Table of Contents
2022-20 Main Ballot Items

2022 TMS 402/602 Committee Response to Public Comment

Committee: Main Committee	Ballot #: 20
Item #: 20-CR- 001	
Technical Contact/Email: Jonathon R. Merk / jon@forrestassociate.com	
Public Comment Number: 2022 Comment # 49	
Public Comment Response Based on TMS 402/602 Draft Dated	10/26/2021
<p>This ballot item proposes the following response to the Public Comment:</p> <ul style="list-style-type: none"> <input type="checkbox"/> <i>Committee agrees with Public Comment, change is proposed</i> <input type="checkbox"/> <i>Committee agrees comment has merit but proposed changes are not completely consistent with Public Comment</i> <input checked="" type="checkbox"/> <i>Committee disagrees with Public Comment and no changes are proposed</i> <input type="checkbox"/> <i>Committee unable to fully develop a response to Public Comment</i> <input type="checkbox"/> <i>Public Comment only requires a response, no change to document</i>

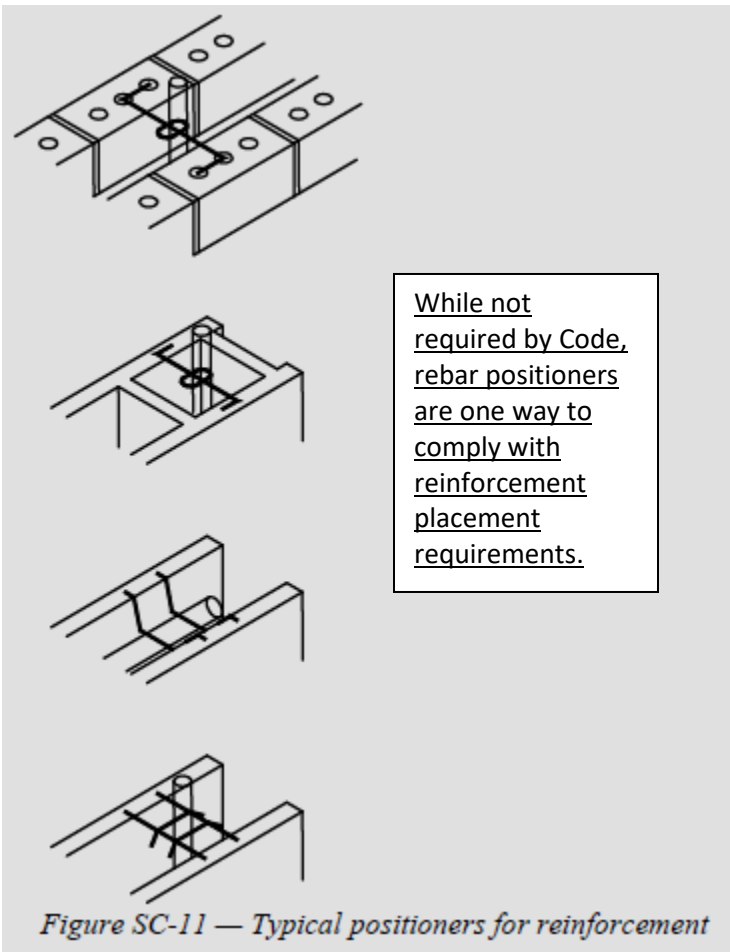
This comment is in regards to the positioners depicted in Specification Commentary Figure SC-11. While the comment is correct that they are not required by Code, they do represent one way to comply with the requirements for the placement of reinforcement. Therefore, CR proposes adding a “disclaimer” to Figure SC-11 as a compromise.

The AWC response suggested an editorial correction that has been incorporated into this ballot.

Figure CC-6.1-8 — Development of flexural reinforcement in a continuous wall with centered reinforcement

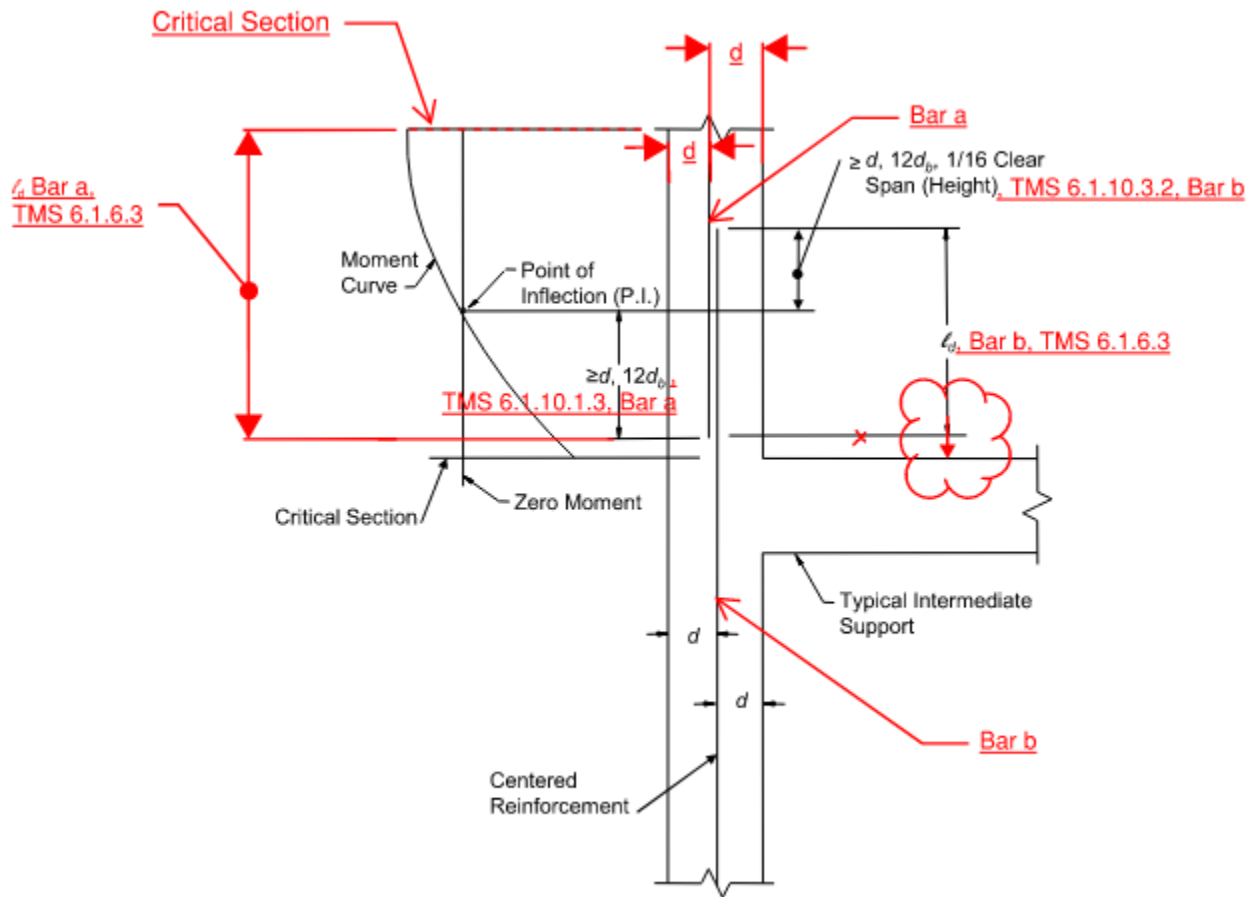
Consider balloting a change to Figure CC-6.1-8 to clarify that the lap shown is not a lap splice but rather the extension of negative moment reinforcement required by Section 6.1.10.

It is often difficult for masonry designers to interpret the intent of existing Figure CC6.1.8 as related to development of flexural reinforcement in a continuous masonry wall – is it a lap splice? Is it an extension of the development length for each bar? What happens when the bars above and below are the same size with respect to terminal ends of positive and negative moment reinforcement?

Proposed changes are underlined in red or clouded in figure CC6.1.8 as shown below.

What if we the commentary said instead "In lieu or providing the development lengths and bar extensions shown in Figure CC-6.1-8, the reinforcing may be made continuous with an appropriate splice."

Figure CC-6.1-3 — Hooked development length

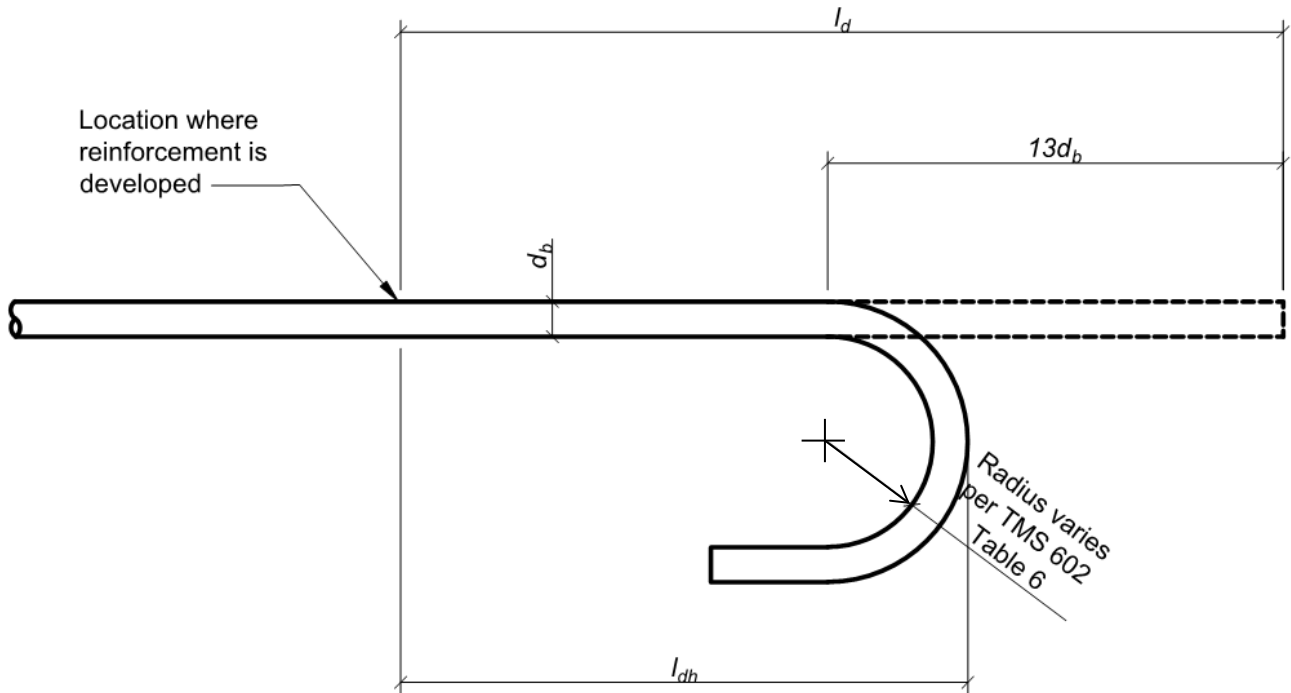
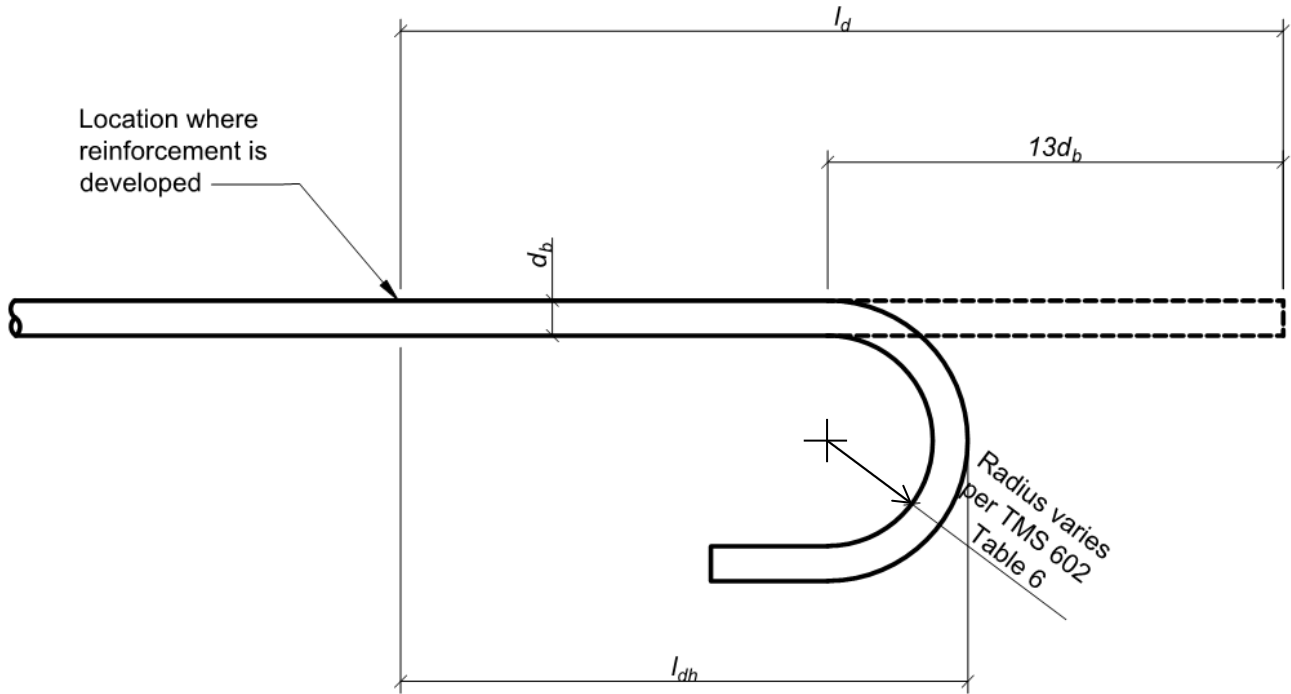
In talking with designers, there seems to be confusion about the application of the provision for development of hooked bars in Section 6.1.6.3.3, with some designers believing that l_e is the development length of a hooked bar, and others believing that the development length of a hooked bar is $l_d - l_e$. Can this be clarified?

The γ_h factor in the proposed Equation 6-3 was determined by subtracting from $13d_b$ the inside radius of hook determined from TMS 602 Table 6 and one bar or wire diameter, resulting in a value for l_{dh} measured to the outside of the bar at the hook. This is illustrated in the proposed Figure CC-6.1-3.

now defines a hooked development length, l_{dh} , in a manner consistent with ACI 318. The γ_h factor in Equation 6-3 was determined by subtracting from $13d_b$ the inside radius of hook determined from TMS 602 Table 6 and one bar or wire diameter, resulting in a value for l_{dh} measured to the outside of the bar at the hook. This is illustrated in Figure CC-6.1-3. It is expected that a more refined and potentially less conservative equation for l_{dh} will be developed for a future edition of this Code.

Figure CC-6.1-1 – Two-celled flanged units, jamb units, and open-end units laid in one-half running bond for concrete masonry units (a), (b), (c), and clay units (d), (e)

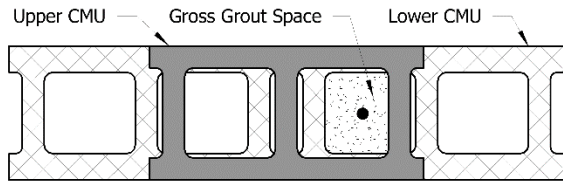
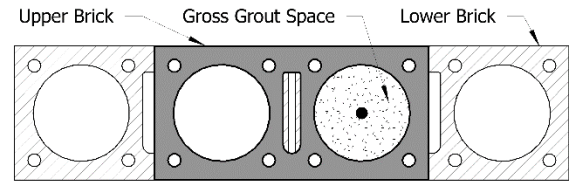
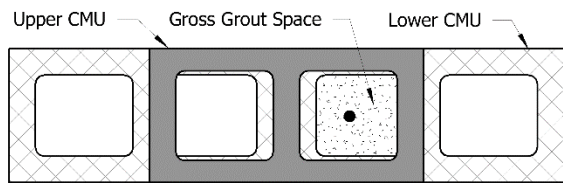
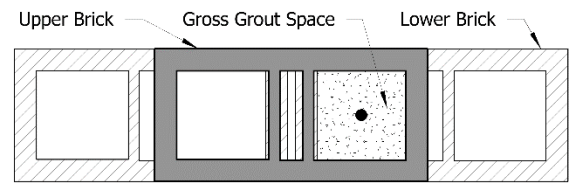
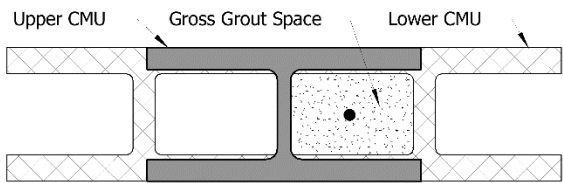
Commentary Figure CC-6.1-1 is a great aid in helping designers understand and then verify available gross grout space. It is, however, mostly representative of CMU although figure (b) may somewhat represent certain structural clay units. Please consider adding additional figures to show a couple generic structural clay unit configurations and their resulting gross grout area when laid in one-half running bond.

6.1.3.2.5 The limitations on maximum reinforcement percentage are based on the gross grout space presented by the cell, bond beam course, collar joint, or AAC masonry core. These limitations are in contrast to the requirements for grout placement in TMS 602 Table 7, which are based on the net grout space per Footnote 3 and TMS 602 Figure SC-21. The limitations of Section 6.1.3.2.5 are intended to avoid overreinforcing, while the limitations of TMS 602 Article 3.5C are intended to prevent problems with grout consolidation. The alternative provisions presented in Table 6.1.3.2.5.1 and Table 6.1.3.2.5.2 provide a simplified method of determining the maximum vertical reinforcement permitted by TMS 402 when designing vertically reinforced two-celled hollow concrete masonry and hollow clay masonry even though the dimensions of the unit cross-section are unknown before the units have been ordered by the contractor. Because these provisions are simplified, they are also conservative. Designers who know the cross-sectional dimensions of the units to be used on the project may be able to specify greater amounts of reinforcement than those shown in these Tables, especially for units greater than 6-in. (152 mm) in thickness. The percentages in these Tables were correlated to the values in Table 6.1.3.2.5 and are based on “per 8-in. (203 mm) length” (per cell or core for two-celled units), with a footnote to address nominal 12-in. (305 mm) long clay units that have a 6-in. (152 mm) length per core or **cell.** Table 6.1.3.2.5.1 applies to units laid in one-half running bond (units overlap 50% of their length) and Table 6.1.3.2.5.2 applies to units laid in stack bond (unit overlap 100% of their length). Figure CC-6.1-1 illustrates two-celled flanged units, jamb units, and open-end units laid in one-half running bond for typical CMU and clay units.

Concrete and clay masonry unit configurations can vary regionally and between manufacturers due to local production preferences. Consult producers local to the project to develop expected unit geometric parameters prior to calculating gross grout space. Other detailing aspects such as corbeling and varied unit overlap can also affect the available gross grout space. Include sufficient notes and/or details to illustrate necessary unit geometry and unit placement limits for compliance with the design basis. Refer to Figure CC-6.1-1 for illustrations of several unit possibilities in one-half running bond pattern. Other bond patterns and unit alignment should be considered when calculating the gross grout space.

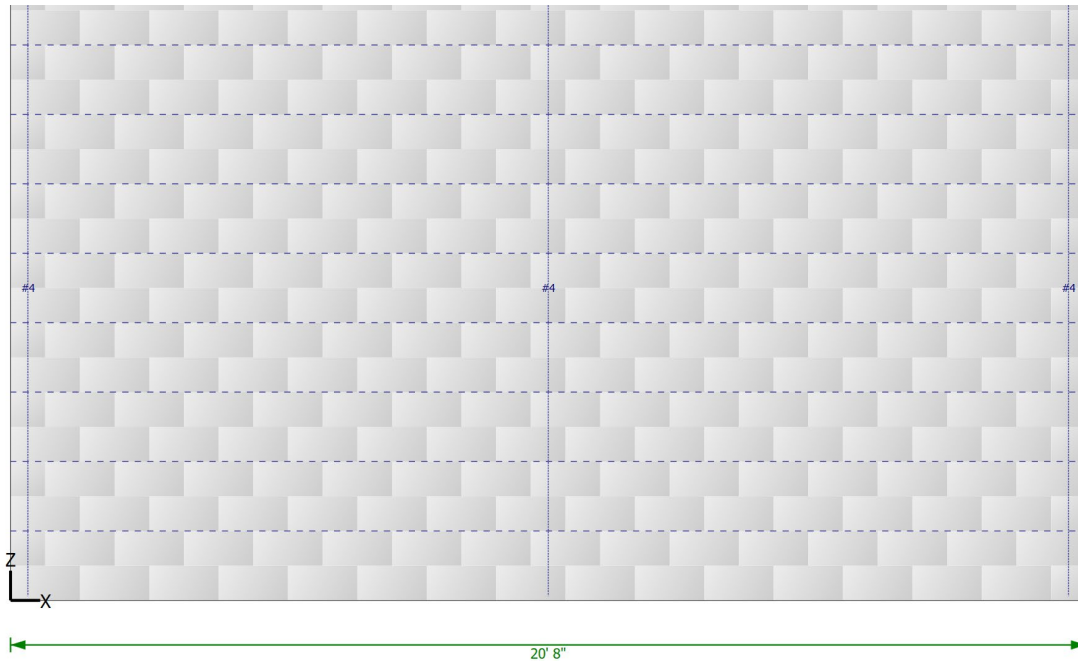
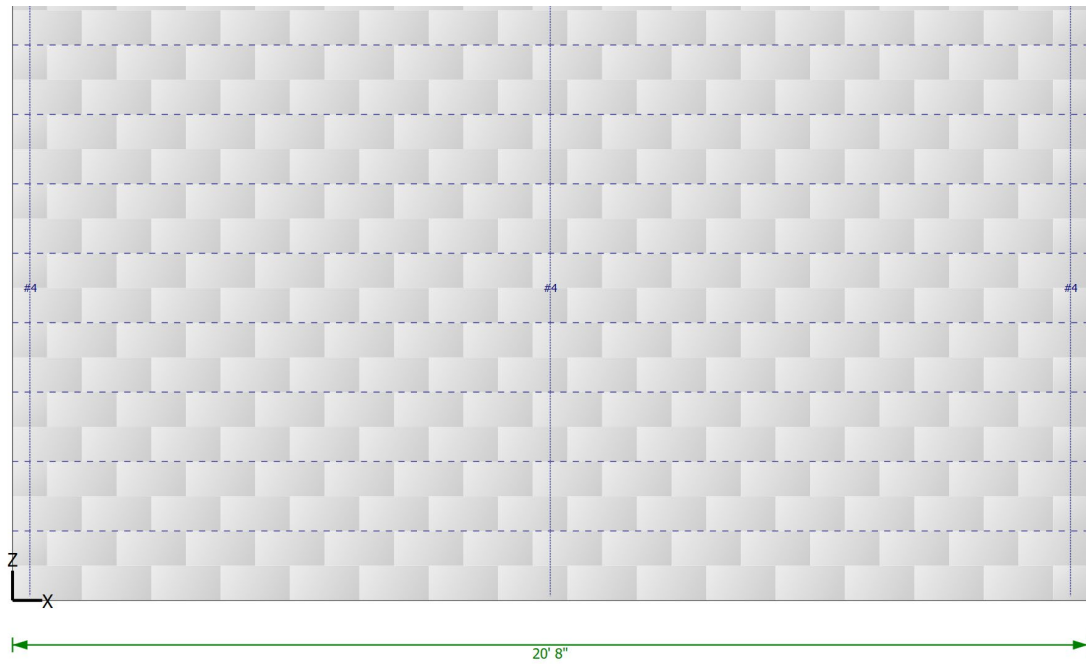
In general, if an assembly is properly designed and detailed (which in this context would require isolating the non participating element from the lateral force resisting system), then a minimum code shouldn't require extra reinforcement just because. If these elements can be designed as unreinforced to respond elastically, then adding the steel provides no benefits for strength or ductility.

If the committee wants to mandate reinforced partitions, let's have that discussion rather than this approach of requiring reinforced masonry to be designed for an elastic response.

As a practical matter, if a lightly loaded, non-participating partition were spanning in the vertical direction and designed as reinforced, the least amount of vertical reinforcement would be spaced at 120 inches. For crack control, this wall would also likely contain bed joint reinforcement at 16 inches on center over its height to yield a design that may look like the following:

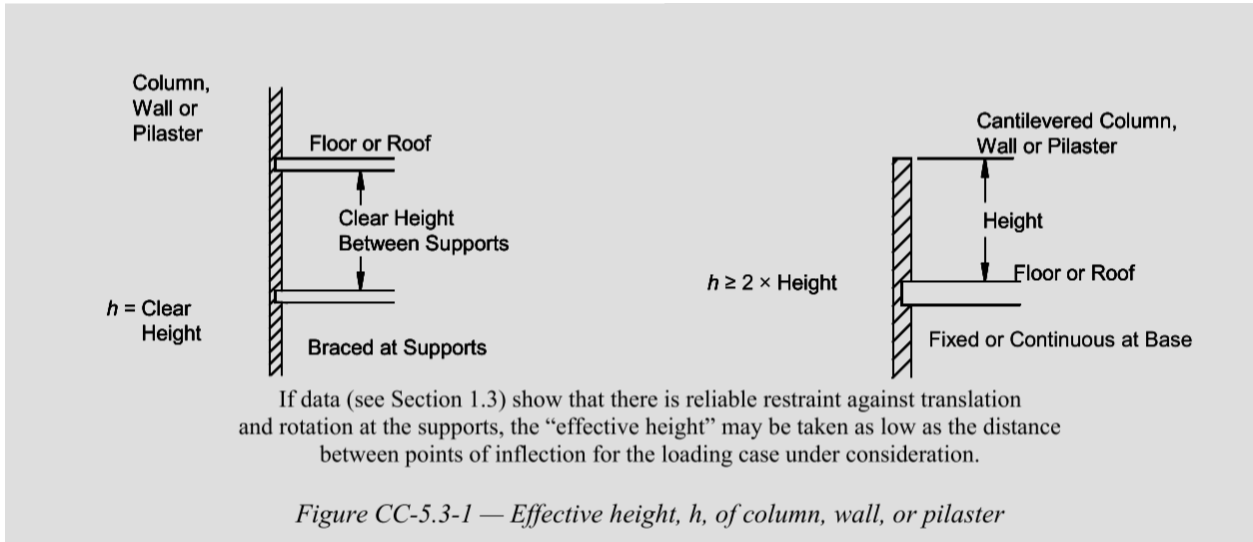
The code limit on column slenderness defines the slenderness in terms of the distance between lateral supports, not the effective height, yet the commentary uses the nomenclature "h" and the terminology "effective height." It is suggested to remove "h/r" from the first sentence of the commentary, and to move the second sentence, along with Figure CC-5.3-1, to Section 2.2 as commentary on the nomenclature "effective height." This would have the additional benefit of making this commentary applicable to walls as well as columns.

Therefore the nomenclature 'h' and 'effective height' are interchangeable and are not in conflict.

The term h/r in the Commentary is a commonly used expression for the slenderness ratio that is used throughout the Code.

Figure CC-5.3-1 is a clarification of the term h and effective height and specifically addresses cantilevered conditions.

Figure CC-5.3-3 — Example of a lateral tie included angle for a clay masonry column

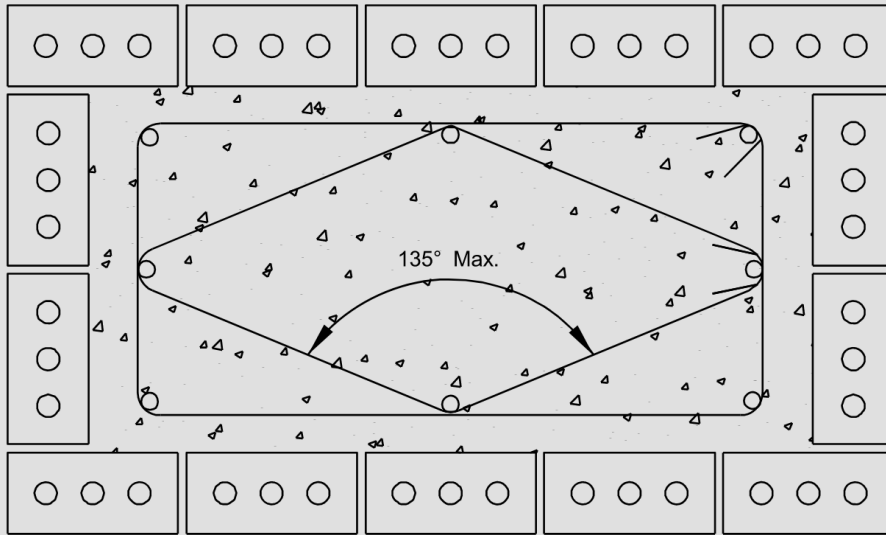
Needs clarification. Seems to say no longitudinal bar can be spaced more than 6 inches with out ties. Figure CC-5.3.3 seems to contradict this requirement.

The committee disagrees with the Commenter's statement that Figure CC-5.3-3 contradicts the requirements stated in TMS 402 Section 5.3.1.4 (c). TMS 402 Section 5.3.1.4 (c) does state that no longitudinal bars shall be spaced farther than 6 in. clear on each side without ties.

Figure CC-5.3-3 is copied below for reference and depicts a reinforced clay masonry column. Figure CC-5.3-3 shows a clay column where the clear space between bars is stated as being greater than 6 in., and it shows all bars laterally supported by ties with an included angle of not more than 135 degrees which is in agreement with TMS 402 Section 5.3.1.4 (c).
